Ahsan Apparels Ltd.

M S Tower-2, Siddhirgonj, Narayanganj.

25th January 2021

Observations

Additional super imposed dead load on floors

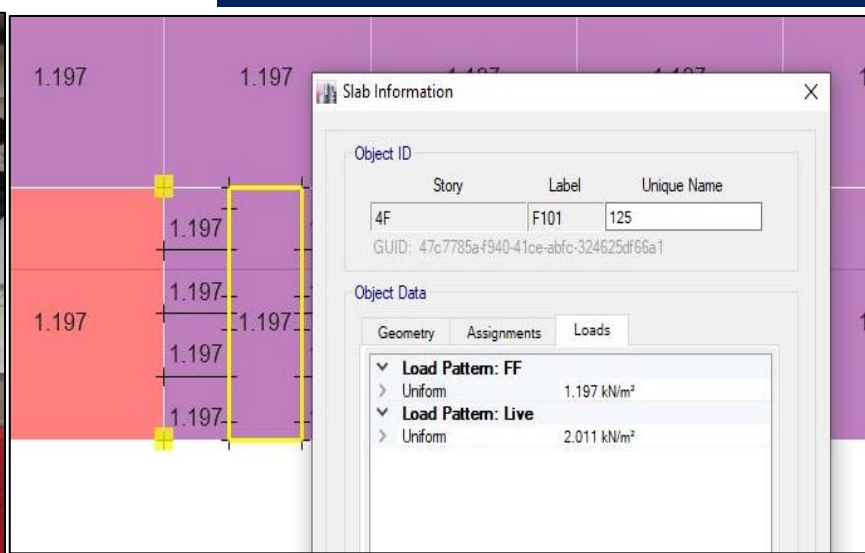
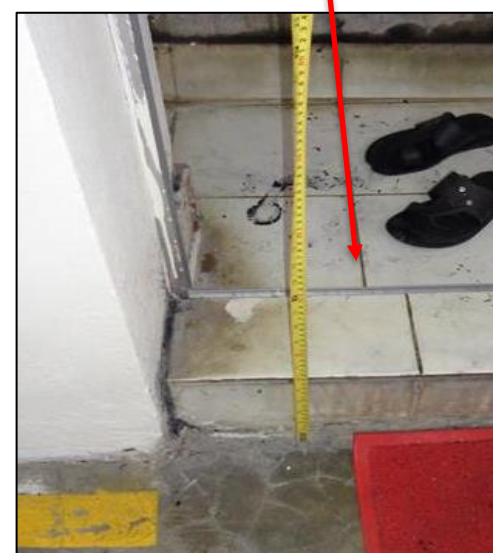
At 4th floor additional 50mm floor finishes was found applied on floor slab along the last grid of north side which increases the dead load. In as-built architectural drawing, the information has not been shown. Additionally, the build-up loading has not been incorporated in FEA model.

Undocumented 100 mm build up was found at toilet zone area. The build-up information has not been shown in as-built drawing. Also the loading from the build-up has not been incorporated in FEA model.

Building engineer is required to check the slab adequacy for this additionally imposed dead loads.

Crack in brick wall

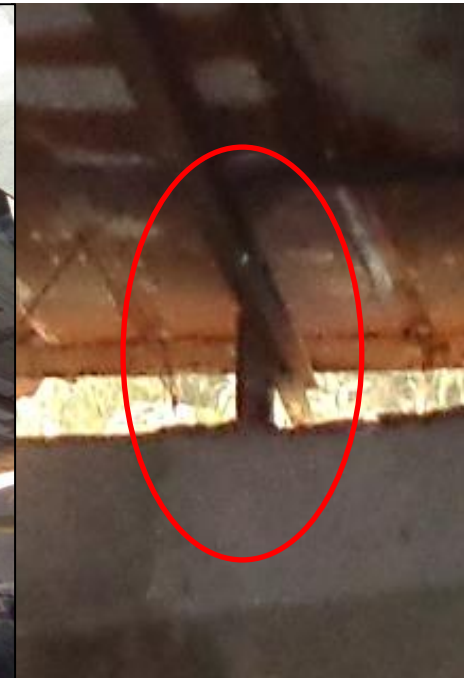
Crack was found in several locations of brick wall. Factory engineer is required to investigate the cause of crack and repair the crack as per recommendation from investigation report.
